802.3df D1.0

Comment Resolution

P802.3df editorial team

Figure 116-2—200GBASE-R inter-sublayer service interfaces

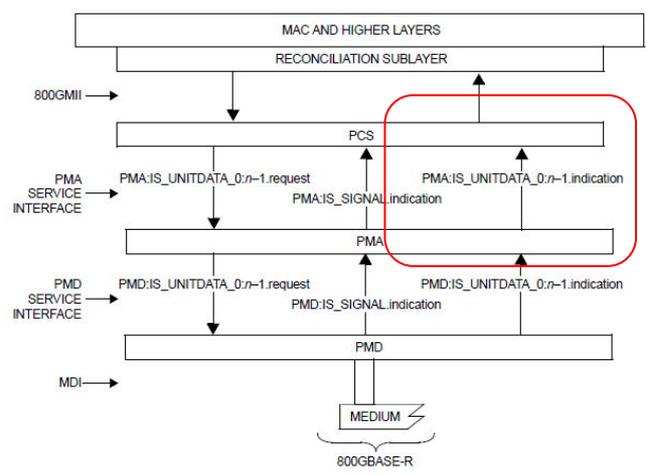
In Figure 116-2, multiple lanes are shown explicitly: PMA:IS_UNITDATA_0.request
 PMA:IS_UNITDATA_1.request ... PMA:IS_UNITDATA_7.request

Suggested Remedy
 As a compromise, follow e.g. Figure 120G-2; add the short diagonal lines "n" to show n lanes, not n requests on one lane with a constant ordering. Several figures, including Fig 172-2 where showing the numbers, 16 and 32, will be helpful.

Proposed Response Response Status W
PROPOSED REJECT.
 A single line with an SI parameter with vector notation clearly conveys the fact that there are multiple lanes 0 to n-1. This approach is used to reduce the clutter compared to similar diagrams in Clause 116. This approach is used consistently in various figures in 802.3df. The proposed changes do not improve the accuracy or clarity of the draft.

In new clauses 169, 173, etc., a parameter vector is used to convey a multitude of lanes, greatly reducing the clutter. Number of lanes is evident both due to the vector format and the related note in the legend.

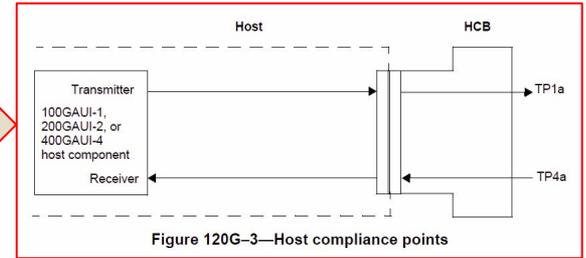
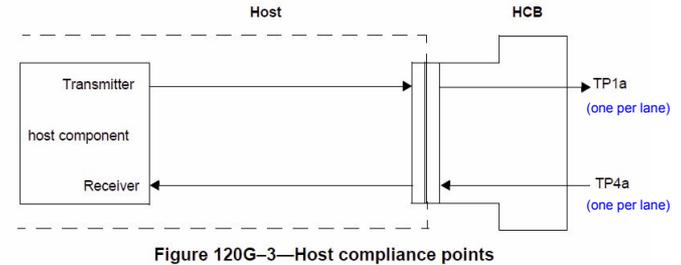
As dealing with larger numbers of lanes in compliance boards is an engineering issue...
 And by the way, it might have been helpful to show that these are differential.

It would help to add the short diagonal lines showing n lanes. Also Figure 120G-4

PROPOSED ACCEPT IN PRINCIPLE.
 The test points are separate for each lane.
 However, the clarity of the figure may be improved.

Add the label "(one per lane)" below TP1a and TP4a in Figure 120G-3, and below TP1 and TP4 in Figure 120G-4.
 In the second and third paragraphs of 120G.2, change "the location of compliance points" to "the location of compliance points for each lane".

Replace Figure 120G-3 with the following:

Figure 172–2—Functional block diagram

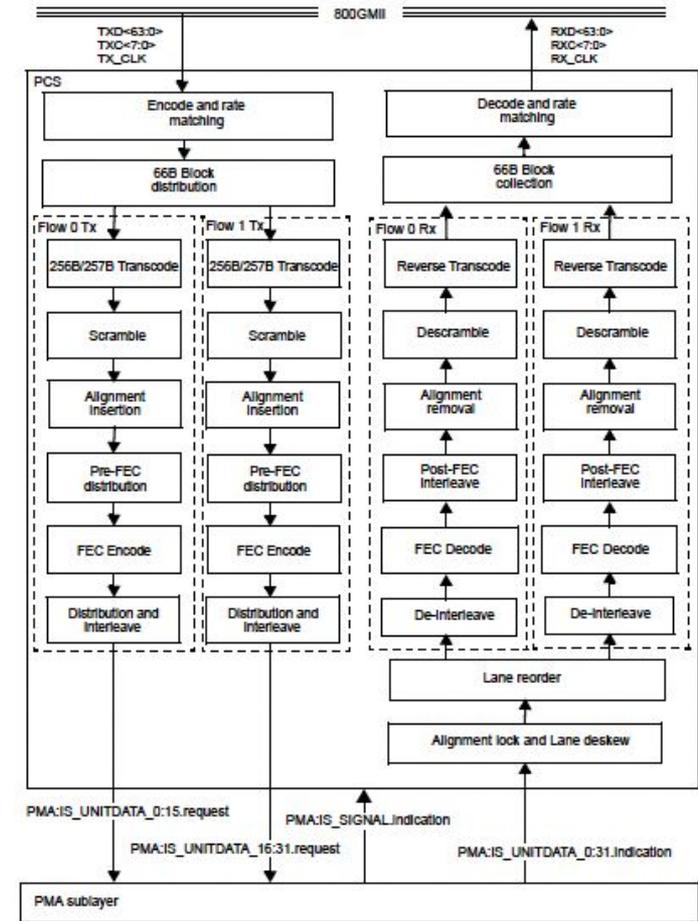
Figure 172-2—Functional block diagram
The block diagram includes two flows for TX and Rx.
Both TX flows are supposed to insert the alignment markers in sync with each other. This does not appear explicitly in the diagram.

The baseline (shrikhande_3df_01a_221004, see slide 10) shows that the two flows' alignment insertion are connected. 172.2.1 ignores this too, although 172.2.4.4 says what to do, but it should be made obvious in the figure that a linkage is needed.

D1.0 uses the highlighted text in 172.2.4.4 to specify the AM insertion requirement shown in slide 13 of the baseline, without defining a specific implementation.

Figure 173-3 (32:8 PMA)

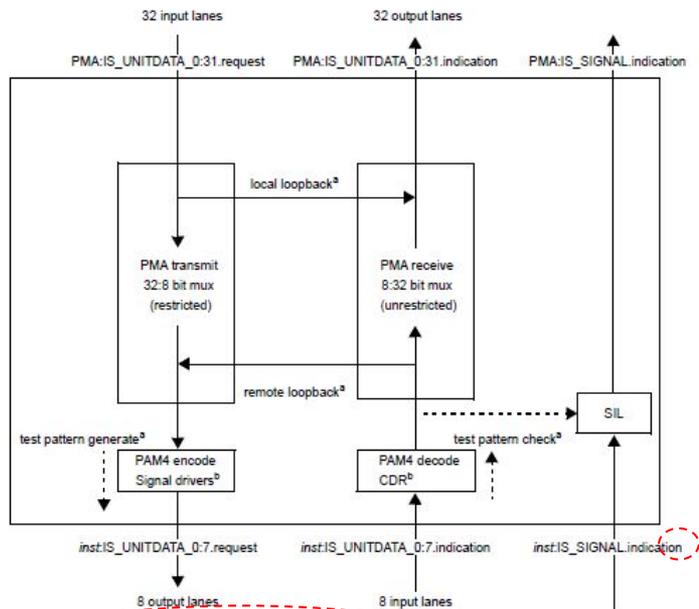
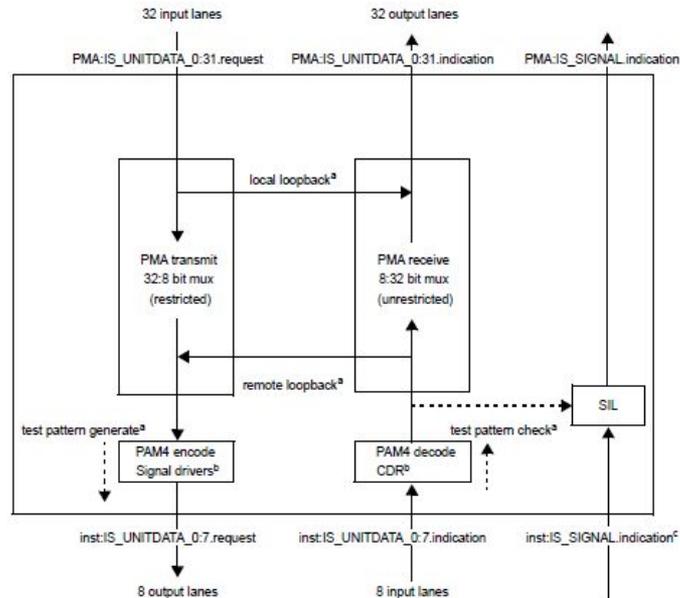
Figure 173-3/4/5/. Need to make it clear if the sublayer above or below is another PMA , that the interface is connected over a physically instantiated AUI (800GAUI-8)

Replace with the following:

- ❖ Update Figures 173-3/4/5 with the corresponding figures shown on previous slides, and update any associated text accordingly.
- ❖ Update Clause 171 according to previous slides, add DTE 800GXS and PHY 800GXS service interface definitions, and update any associated text accordingly.
- ❖ Update Figure 169-3 based on the figure shown in previous slide and update any associated text accordingly.

Figure 173-4 (8:32 PMA)

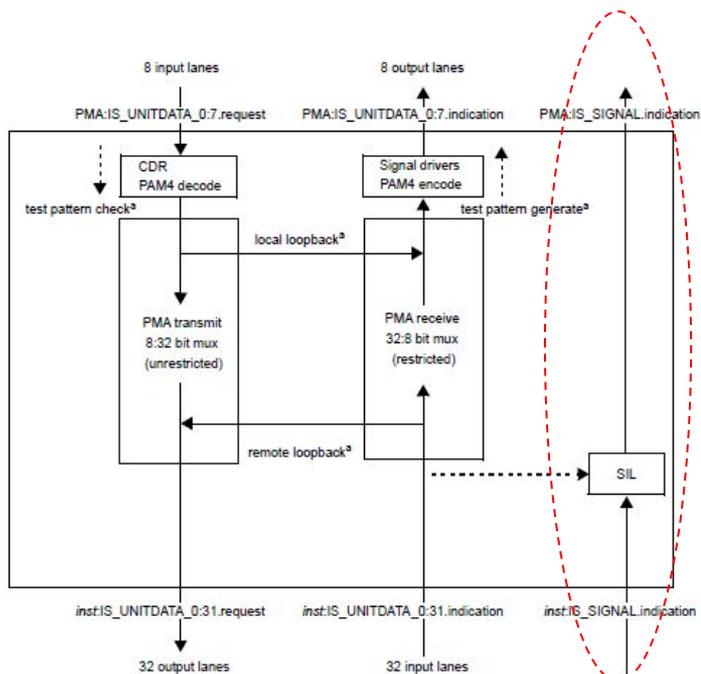
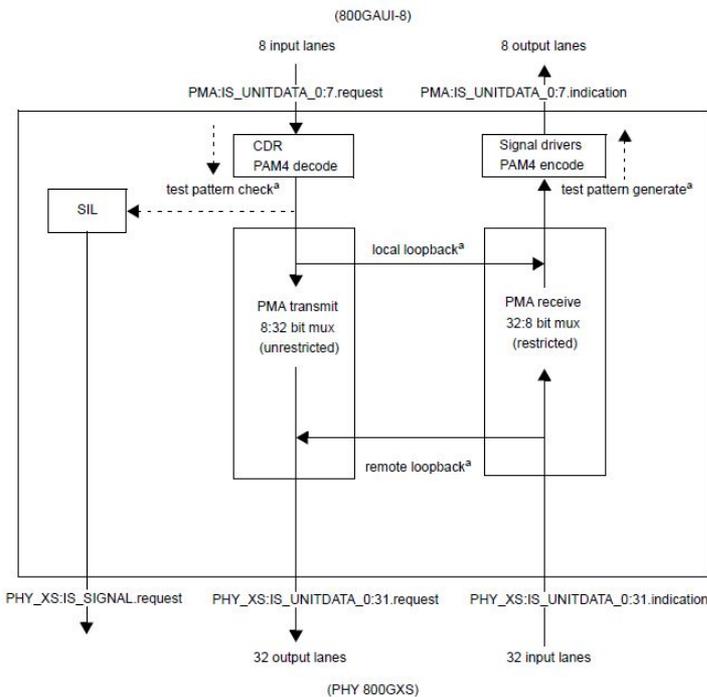
Figure 173-4 (8:32 PMA) there should be no PMA:IS_SIGNAL.indication towards the PMA (AUI is not able to transfer an out of band status signal) and possibly no "SIL" block in the block diagram.

"In the case where the sublayer below the PMA is a PHY 800GXS the PMA does not receive a PHY_XS:IS_SIGNAL.indication as an input to the SIL". Figure 173-4 that describes this interface does include the PHY_XS:IS_SIGNAL.indication

Remove the PMA:IS_SIGNAL.indication signal and the "SIL" block from Figure 173-4 and Figure 173-5.

Replace with the following:

Figure 173-5 (8:8 PMA)

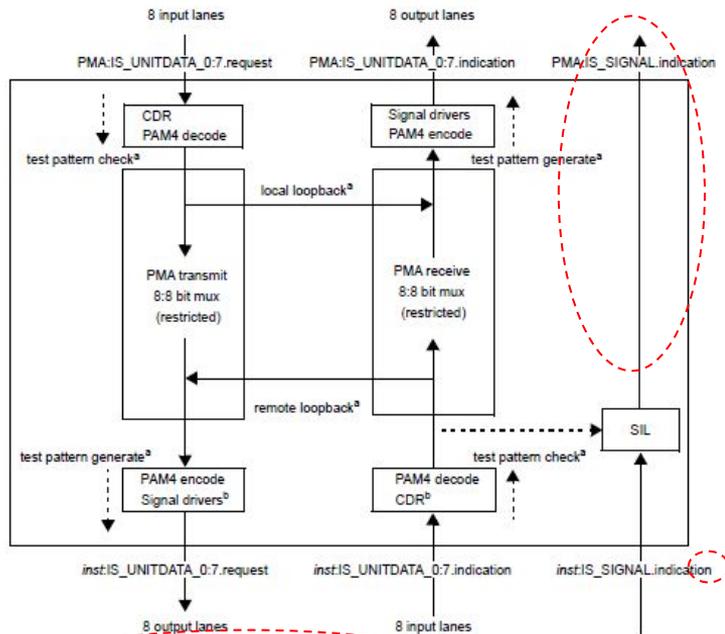
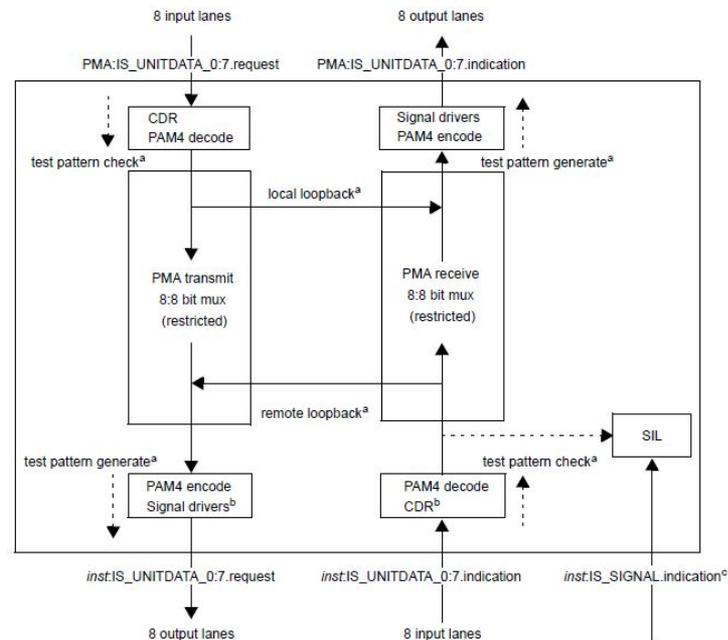
The same comment applies to the 8:8 PMA in Figure 173-5.

Replace with the following:

Figure 169-3

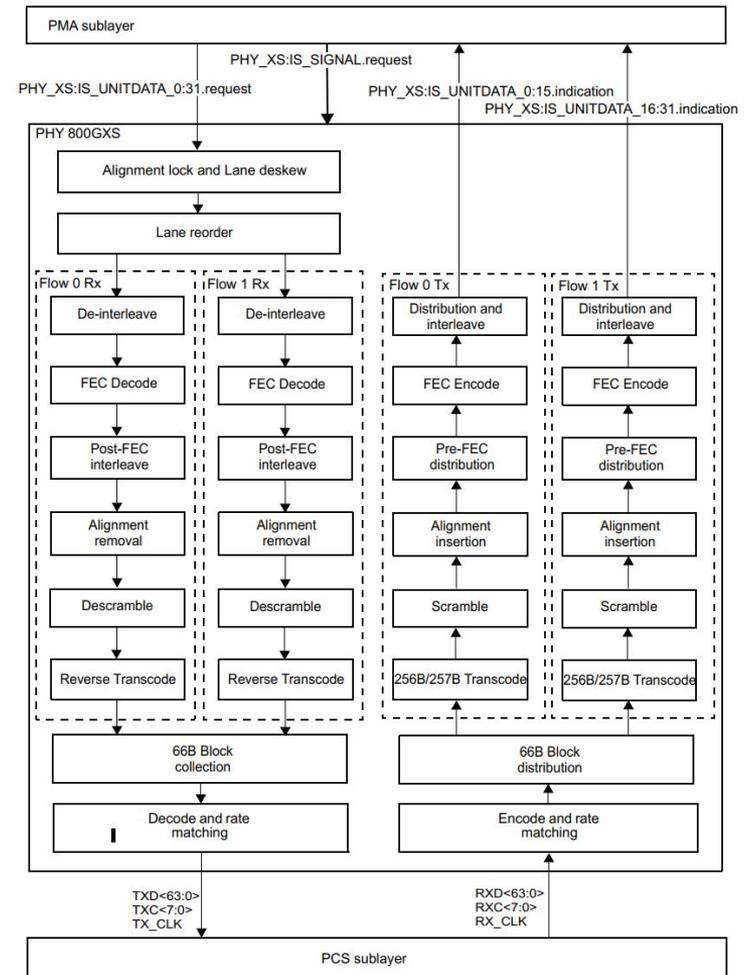
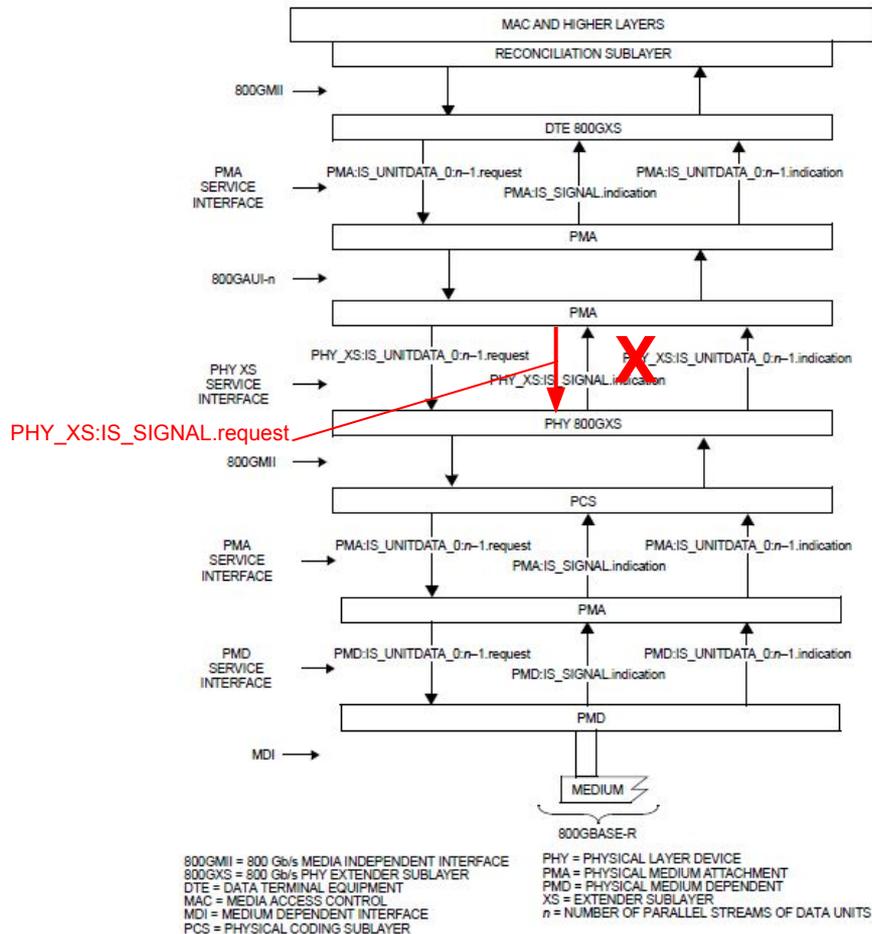
- ❖ The PHY 800GXS functionality and service interface is not explicitly defined in Clause 171.
- ❖ The functional block diagram for the PHY 800GXS is shown on this slide.
- ❖ The PHY 800GXS is essentially an upside down 800GBASE-R PCS, and as a result the service interface is somewhat different to the 800GBASE-R PCS service interface that is defined in Clause 172 (for example the service interface receives an IS_SIGNAL.request signal and rather than an IS_SIGNAL.indication signal)
- ❖ Clause 171 should be updated to show the PHY 800GXS functional block diagram and to define the PHY 800GXS service interface.

❖ Update Figure 169-3 as shown.
